ADDENDUM NO. 1

PROJECT TITLE:
BRIDGE NO. 03160A-D, 3301 & 3303 I-84 EB/WB OVER AMTRAK & LOCAL ROADS (AETNA VIADUCT)

PROJECT NO. **63-699**
DRAWING NO. **S-55**
SHEET NO. **01.08.059.A11**

TOWN: **HARTFORD**
DRAWING TITLE:
SUBSTRUCTURE REPAIR - BRIDGE 3160B PIER NO. ES3

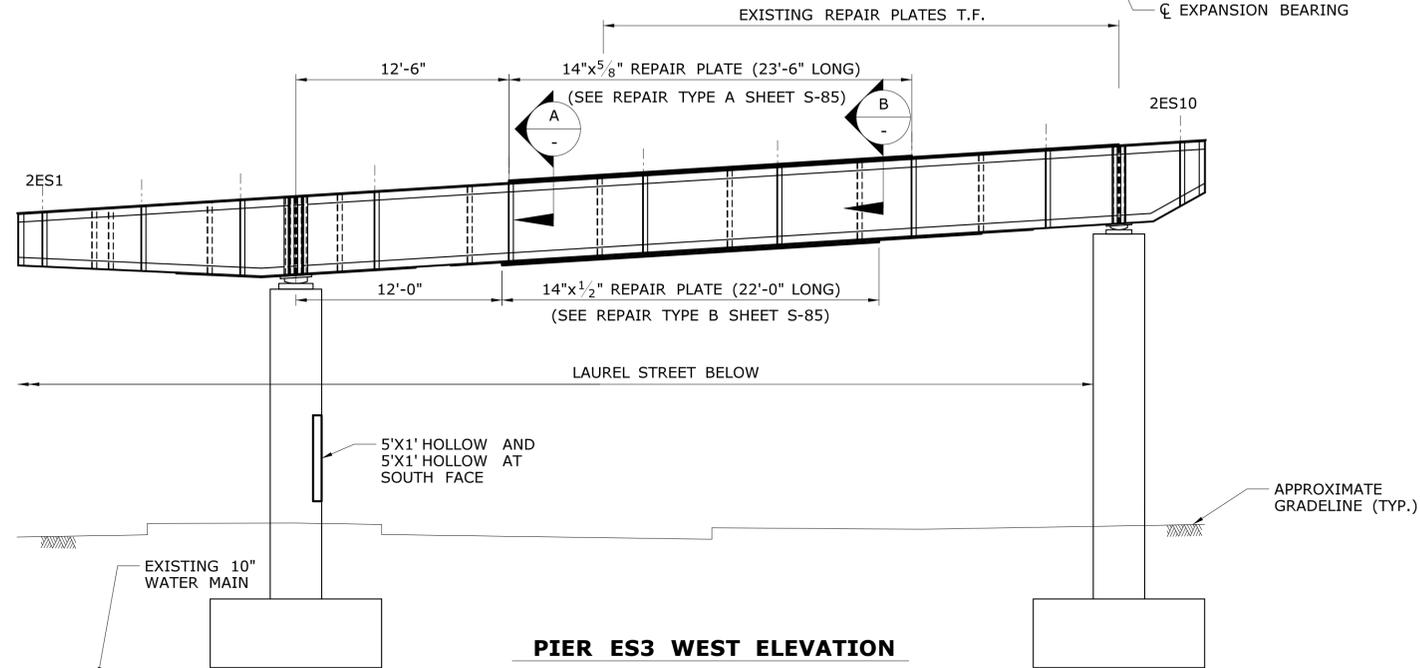
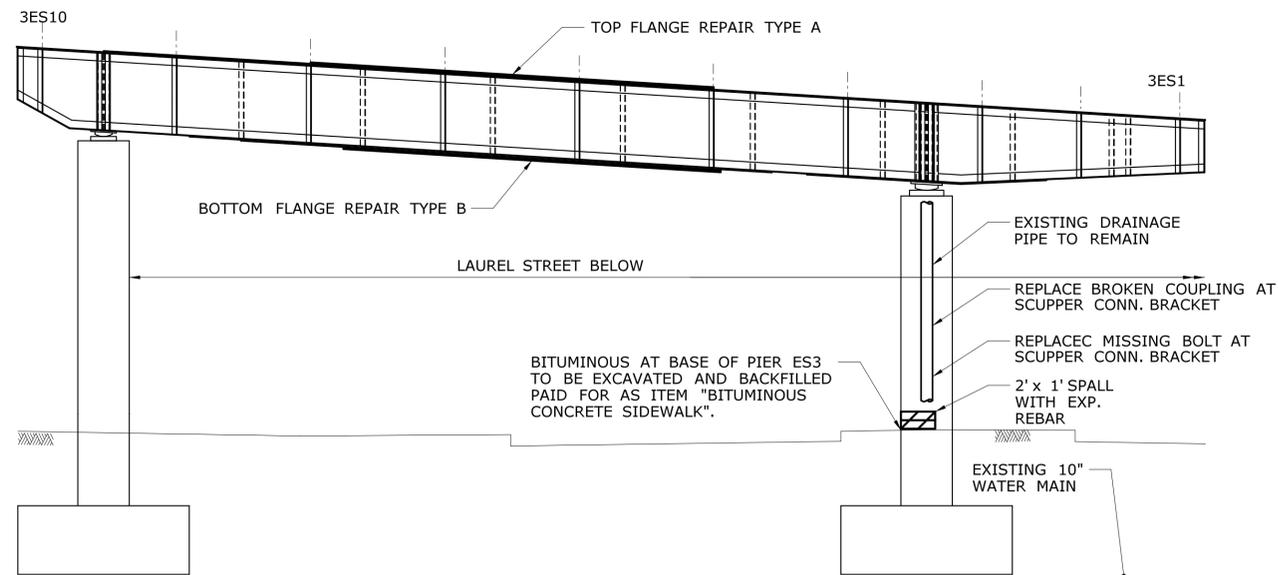
REV.	DATE	REVISION DESCRIPTION	SHEET NO.
1	9/29/16	PLOT LIMIT MODIFICATION	01.08.059

TOWN: **HARTFORD**
 DRAWING TITLE: **MEDIAN DETAILS - 1**

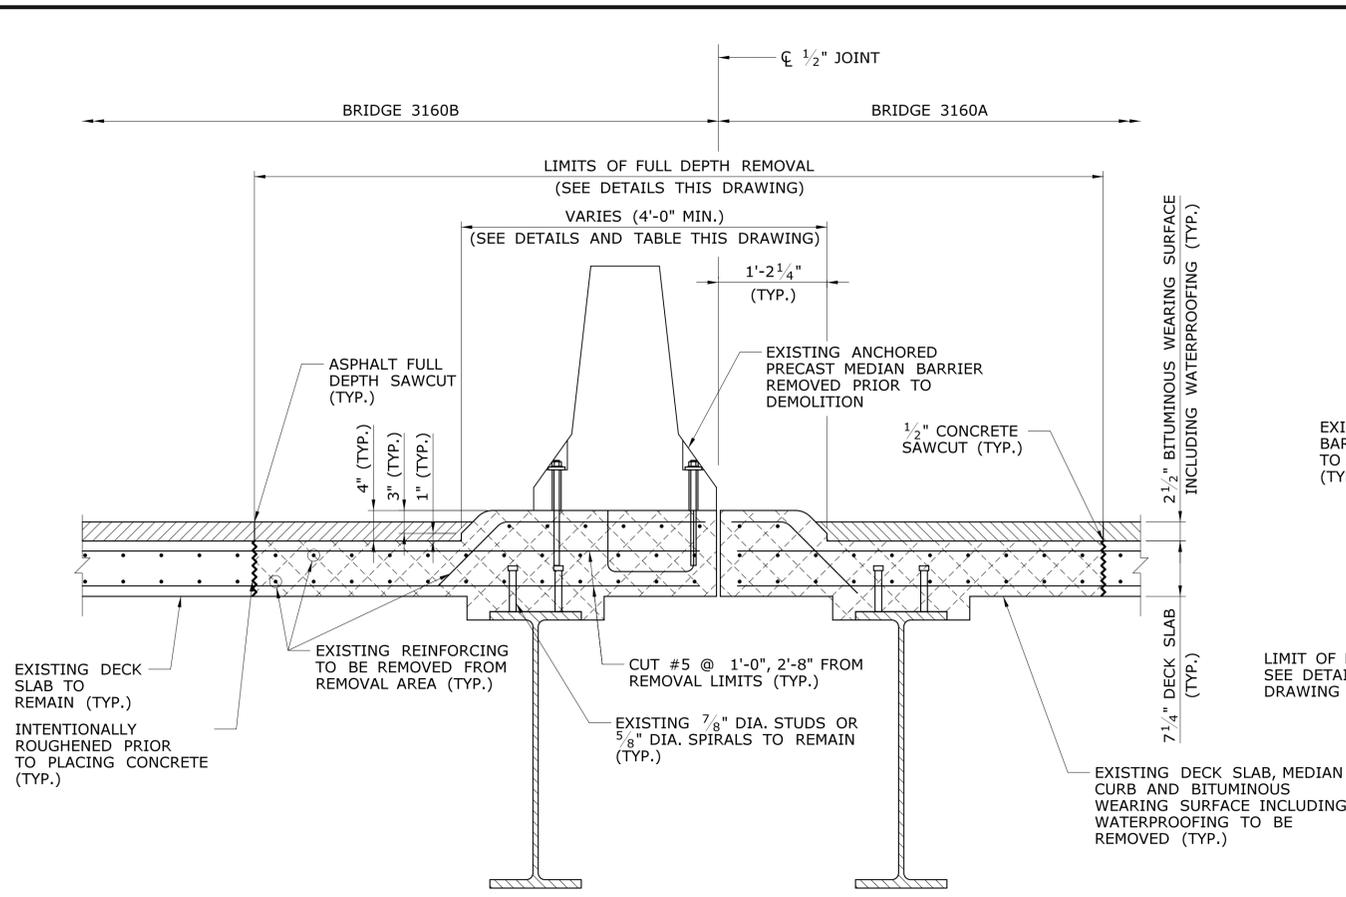
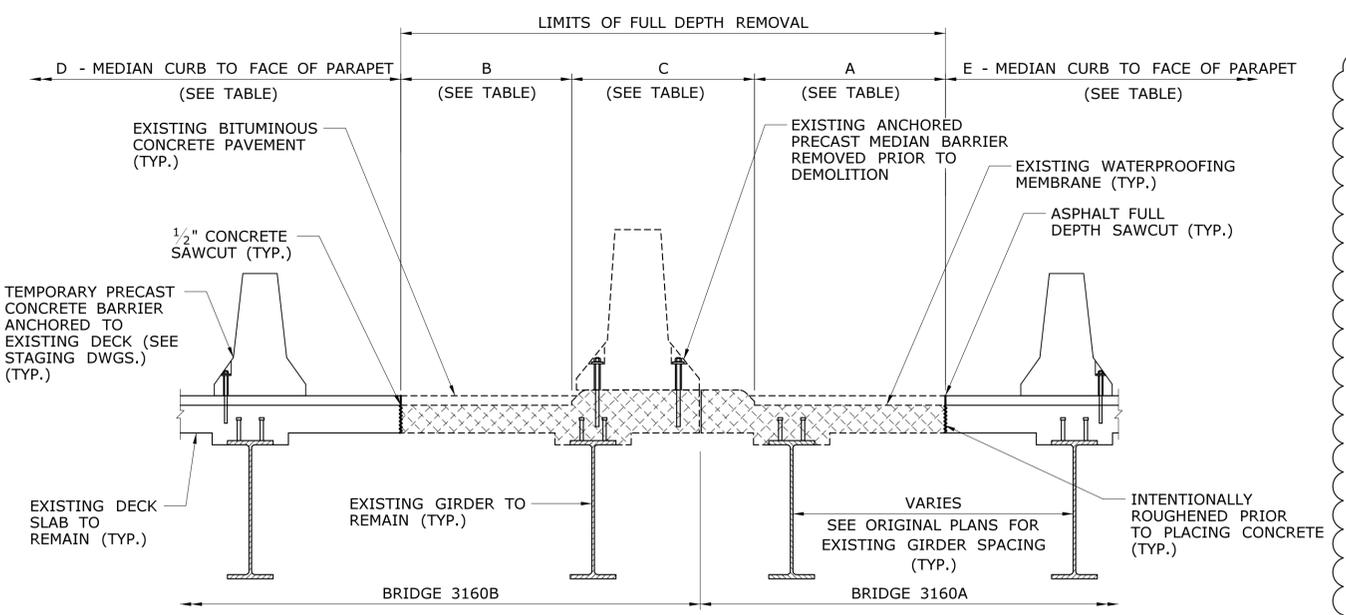
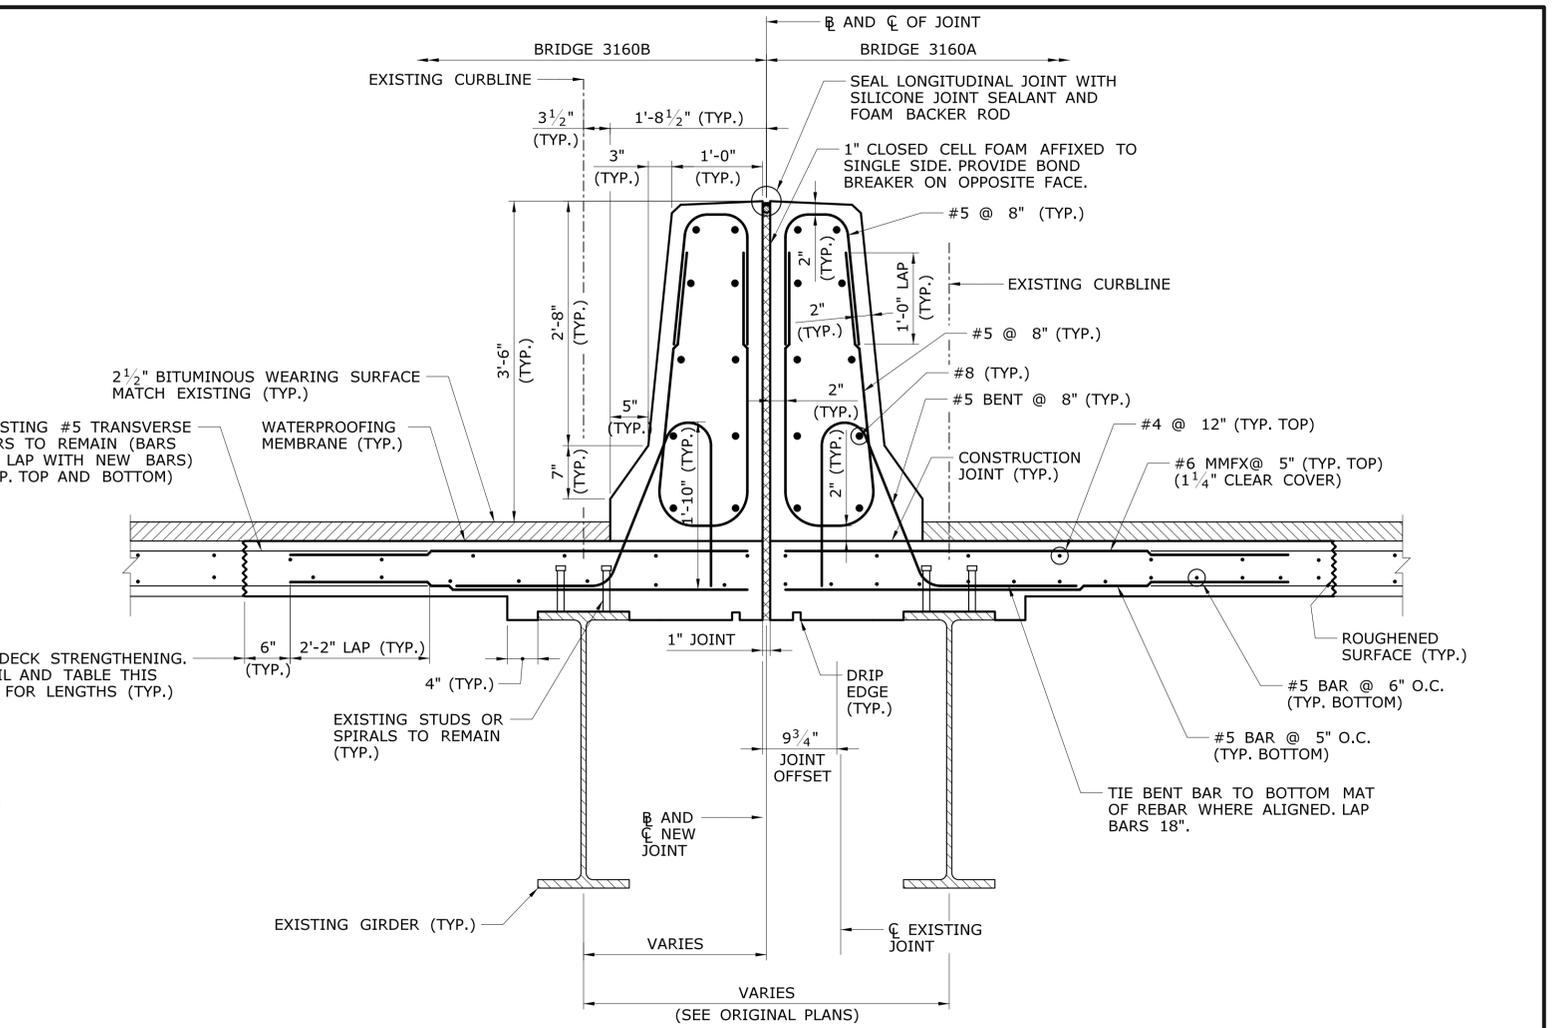
REV.	DATE	REVISION DESCRIPTION	SHEET NO.
1	9/29/16	REVISED MEDIAN REMOVAL LIMITS	01.08.115
		REVISION DESCRIPTION

TOWN: **HARTFORD**
 DRAWING TITLE: **DRAINAGE DETAILS**

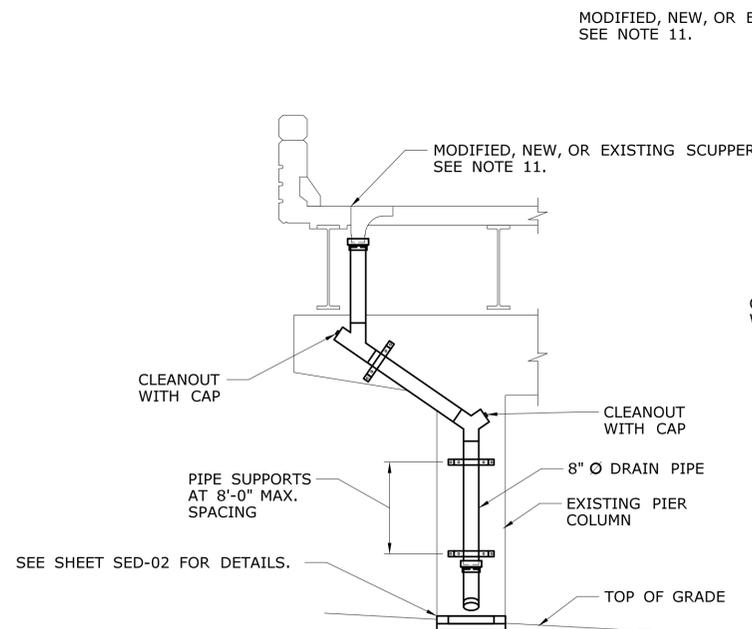
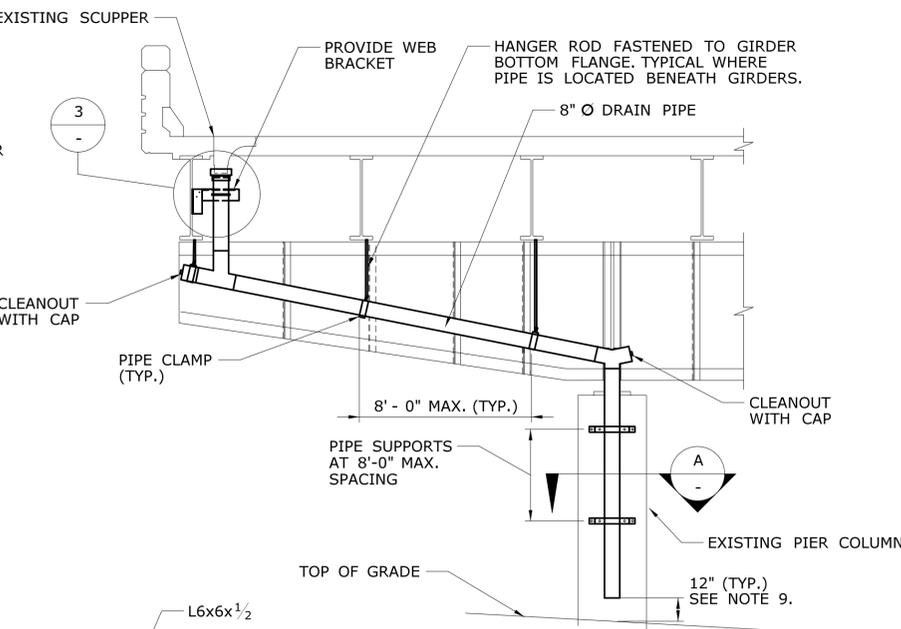
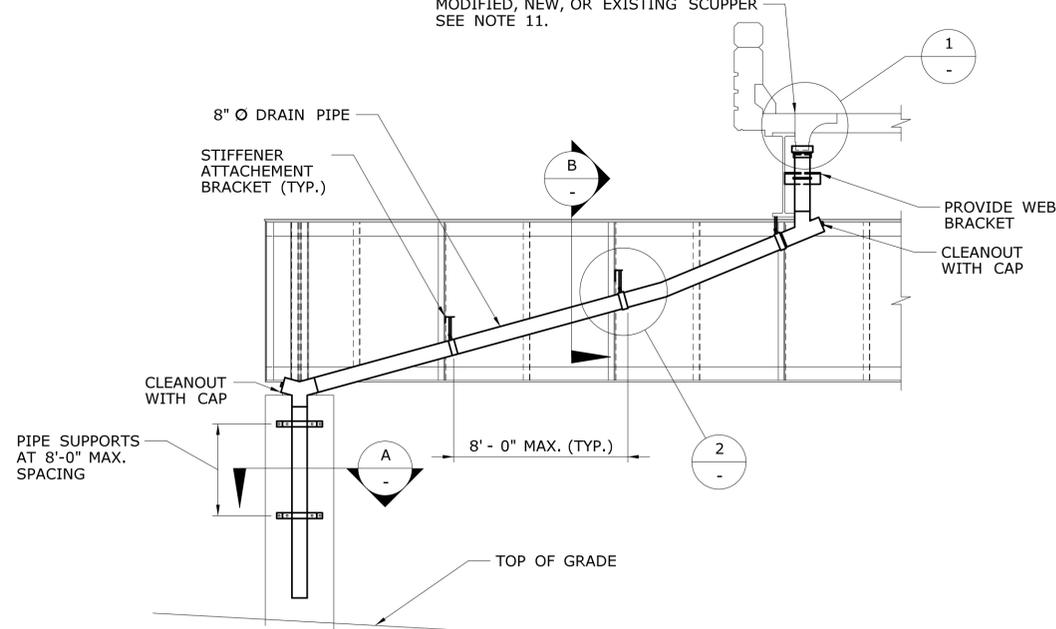
1	9/29/16	REVISED GENERAL NOTES	01.08.125
REV. DATE		REVISION DESCRIPTION	SHEET NO.
